Access Compliance Report

Public Rights-of-Way

(Curb Ramps)

Intersection ID: 11521	Main Street: W_11TH_ST	Cross Street: N_CHURCH_ST	Location: W
ADA ID: 07E98B428DD2	Ramp Type: BlendTrans1	Initial Pass/Fail: Fail	Overall Compliance: No
Severity Score: 12.5			
Codes/Mitigation Info/Possible Solution		Field Measurements/Component Compliance

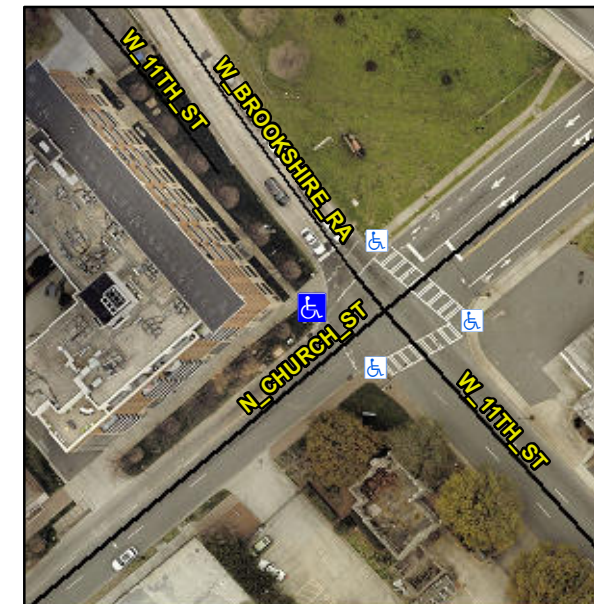
Compliance	Description	Data	Compliance	Description	Data
N/A	Ramp Length (in)	66.0	Yes	BlendTrans Slope (%)	5.0
Yes	Ramp Width (in)	70.0	No	BlendTrans XSlope (%)	5.7
N/A	Flare Type LT	N/A	N/A	Flare Type RT	N/A
N/A	Flare Slope LT (%)	N/A	N/A	Flare Slope RT (%)	N/A
N/A	Flare Traversable LT?	N/A	N/A	Flare Traversable RT?	N/A
N/A	Landing Length (in)	N/A	N/A	DWS Provided?	N/A
N/A	Landing Width (in)	N/A	N/A	DWS Contrast?	N/A
N/A	Landing Slope (%)	N/A	N/A	DWS Length (in)	N/A
N/A	Landing X Slope (%)	N/A	N/A	DWS Full Width?	N/A
N/A	Landing Curb? (Y/N)	N/A	N/A	DWS Offset (in)	N/A
N/A	Shared Landing?	N/A			
N/A	Gutter Ponding?	N/A	N/A	Gutter Slope (%)	N/A
N/A	Gutter Lip Ht (in)	N/A	N/A	Gutter X Slope (%)	N/A
N/A	Painted X Walk1?	Yes	N/A	Painted X Walk2?	Yes
	X Walk 1 Direction	To SE		X Walk 2 Direction	To NE
	X Walk 1 Width (in)	114.0		X Walk 2 Width (in)	111.0
	X Walk 1 Slope (%)	5.5		X Walk 2 Slope (%)	1.0
	X Walk 1 X Slope (%)	0.6		X Walk 2 X Slope (%)	4.9

Remove & Replace Curb Ramp With Two New Directional Ramps or Equivalent.

R304.5.3
